**BOARD OF APPEALS, CITY & COUNTY OF SAN FRANCISCO**

Appeal No. **26-004**

**PRELIMINARY STATEMENT FOR APPEAL NO. 26-004**

I / We, **Gregory Wesolowski**, hereby appeal the following departmental action: **ISSUANCE** of **Alteration Permit No. 2022/12/28/9265** by the **Department of Building Inspection** which was issued or became effective on: **January 13, 2026**, to: **Marc Sherry and Marissa Huang**, for the property located at: **45 Prospect Avenue**.

*Exhibit E-2: Sketch of section "RW10" on page 32 of building plans for 45 Prospect Ave*

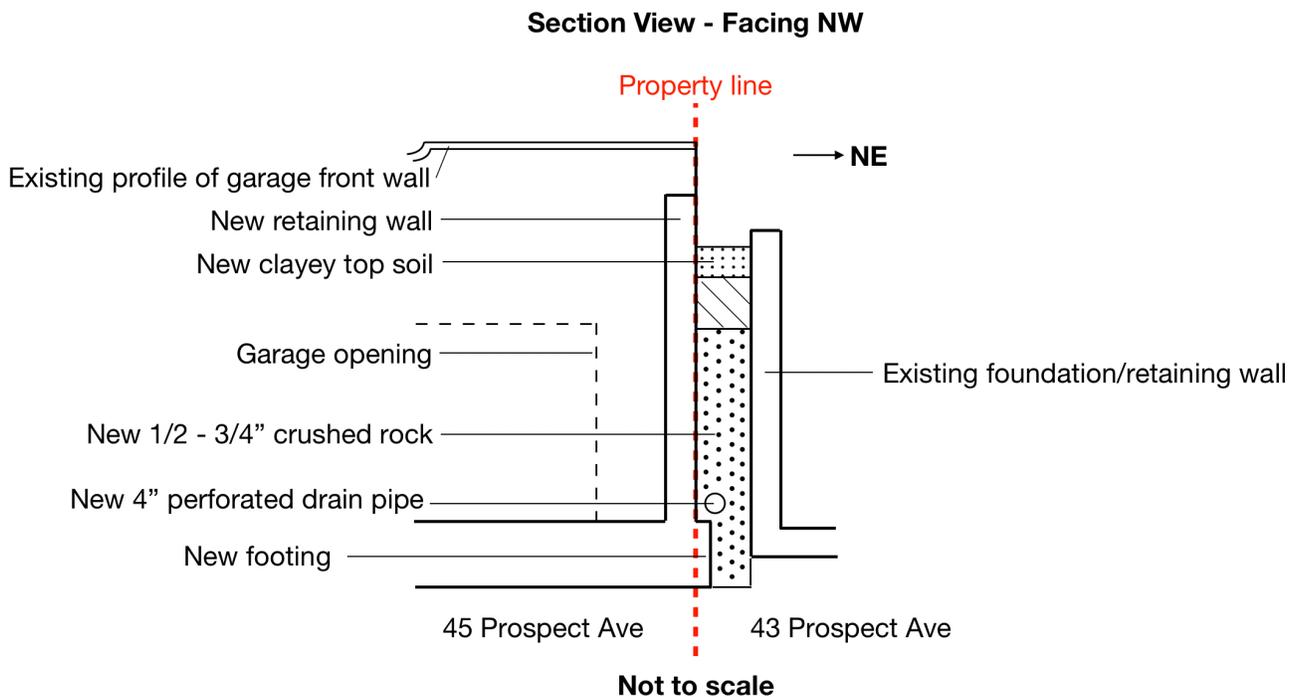
Section view RW10 on page 32 of the building plans has a more detailed illustration of the perforated drain pipe implementation. Exhibit E-2 below shows the perforated drain pipe entirely on my property according to the building plans.

Exhibit E-2 above shows the addition of crushed rock and clayey topsoil to be added on my property as part of the foundation work on 45 Prospect Ave. I did not approve of any construction material to be added to my property. I am also concerned of what impact this could have to the integrity of my foundation/retaining wall.

The approved plans show a new foundation footing extending beyond the property line of 45 Prospect Ave and into my property. Exhibit E-2 shown above from page 32 of the building plans shows the encroachment and this was neither reviewed nor approved.

To address the concerns raised in the Appellant's Brief, we have instructed our engineers to finalize a full redesign of the foundation and drainage systems. While our structural and soils engineers maintained that the original plan—which utilized shared drainage and work up to the property line—represented a "best practice" for the long-term stability of both properties, we are voluntarily moving away from that design to respect the Appellants' preference for absolute boundary separation.

these footings provide maximum structural stability for our house-lift without crossing the boundary. Once this technical solution is finalized, it will be submitted to DBI for formal approval.

**Independent Drainage and Neighbor Responsibility** As noted in the original Site and Drainage Plan, the previous design utilized drainage infrastructure placed along the boundary. We are now relocating all drainage systems entirely to the 45 Prospect side of the line. Consequently, 43 Prospect will become an entirely independent system. This means Mr. Wesolowski and Ms. Cretella will now maintain exclusive responsibility for the management of their own runoff, water mitigation, and drainage maintenance. This change provides the legal and physical independence the Appellants requested.

*Exhibit F-1: Sketch of section of page 4 of building plans for 45 Prospect Ave*

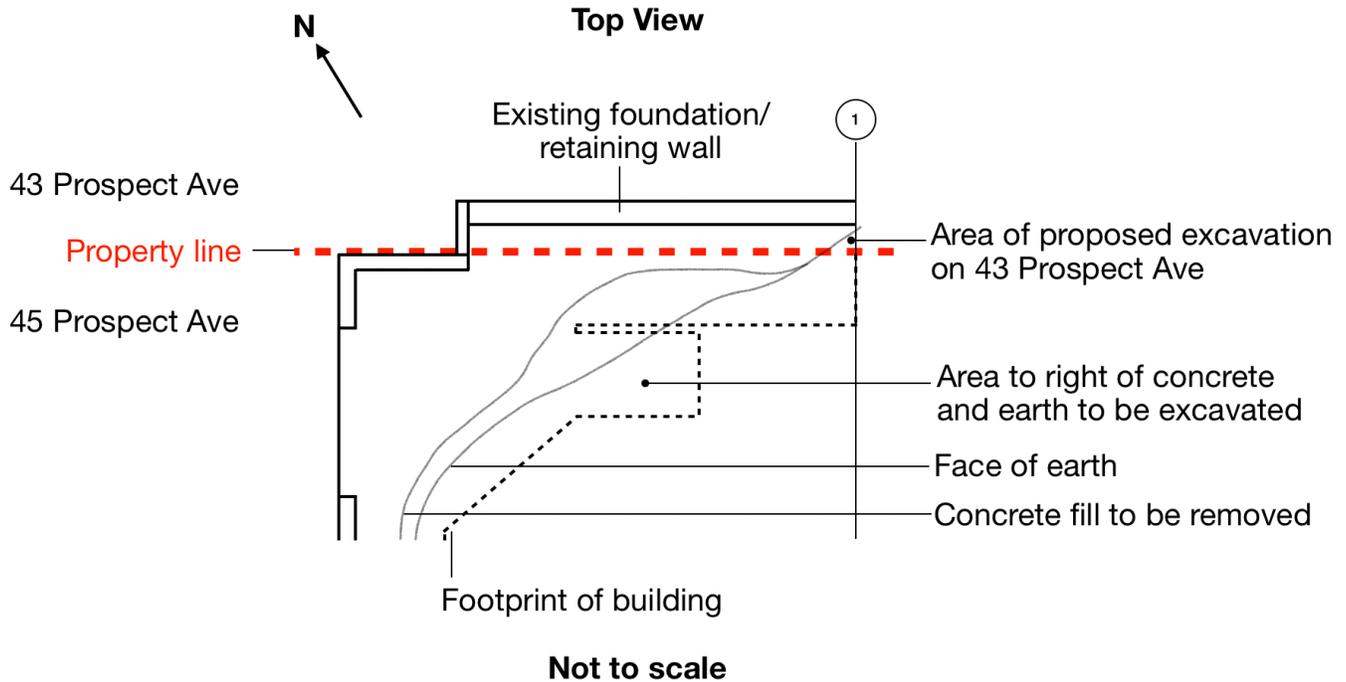
Page 4 of the building plans for 45 Prospect Ave also outline where excavation will occur in order to create space for a garage and storage room. Exhibit F-1 on the next page shows that a small section of my property is included in the excavation plans. This was neither reviewed nor

approved and I am concerned what risk this may pose to my foundation/retaining wall, in addition to loss of use of my property.

**Revised Excavation Limits** Because we are no longer installing shared drainage infrastructure at the boundary, we are revising the excavation limits shown on the original Garage Level Excavation plan. We are pulling back these boundaries to provide a buffer between our project and the property line. This ensures the integrity of the earth adjacent to the Appellants' foundation and removes any risk of encroachment during the construction process.

1 (N) SITE DRAINAGE PLAN  
A1.1 1/4" = 1'-0"

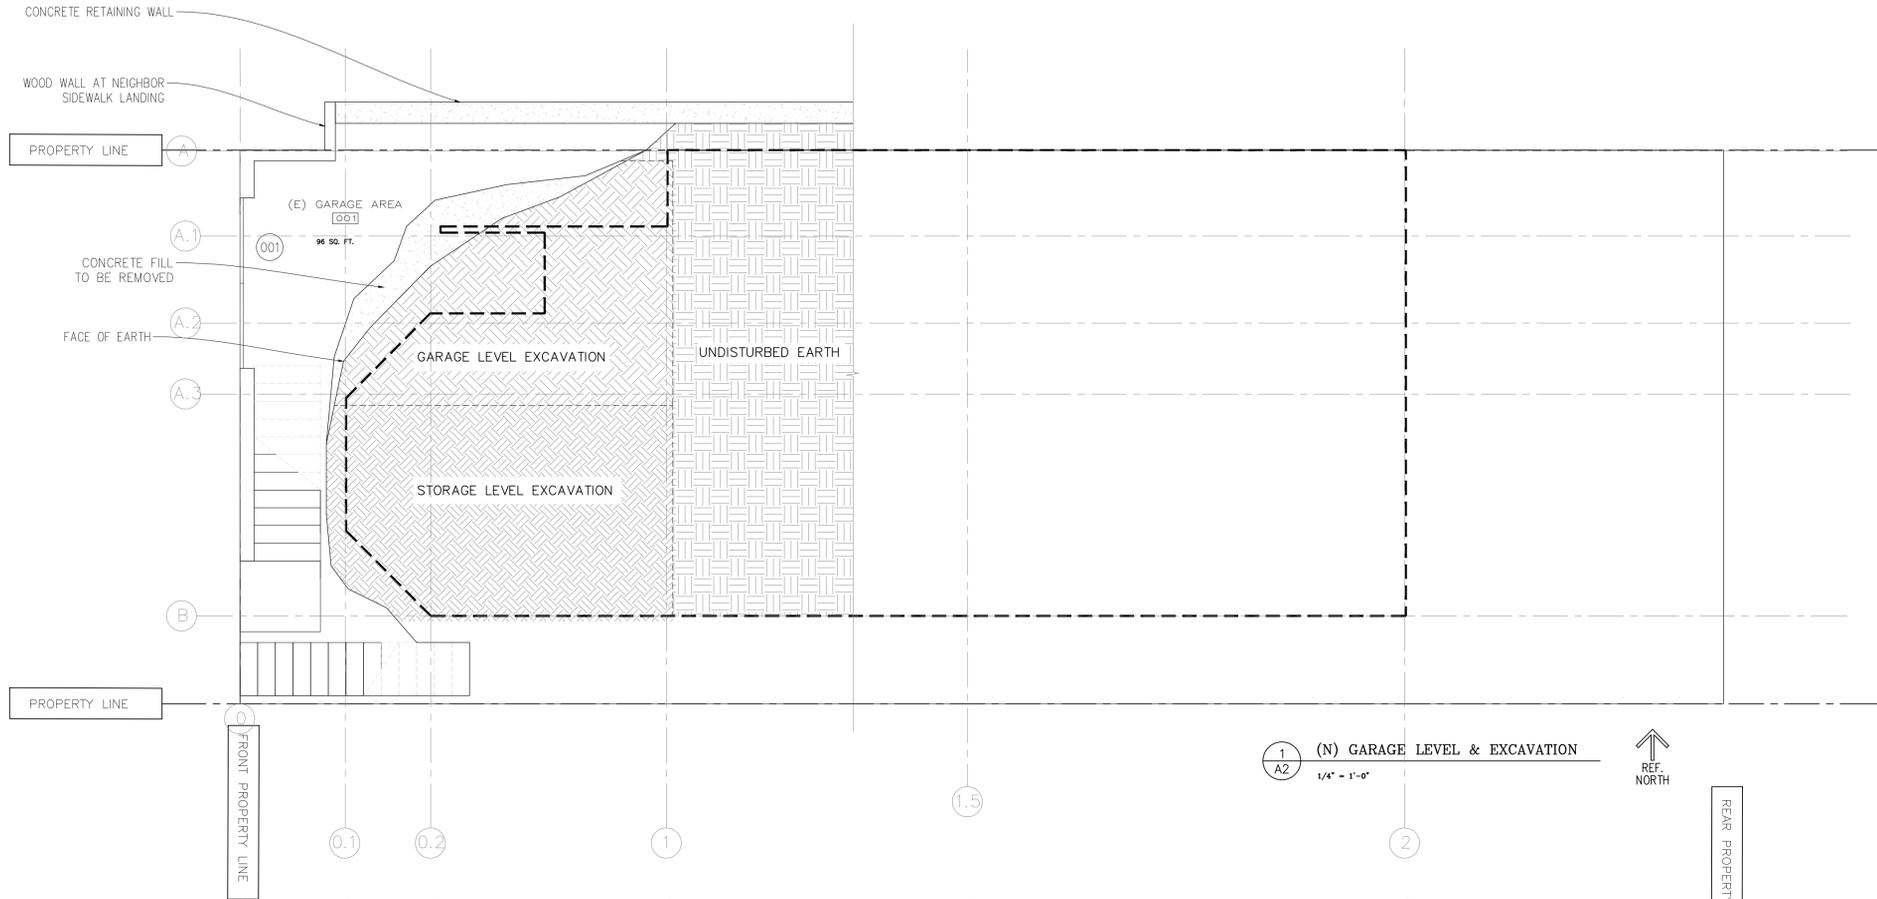
The plans for 45 Prospect Ave. include installation of a 4-inch perforated drain pipe located within my property boundaries. No approval was given for this proposed installation. Page 3 of the building plans show a top view of both 43 and 45 Prospect Ave., and Exhibit E-1 on the next page shows a sketch of the relevant section of the building plans.
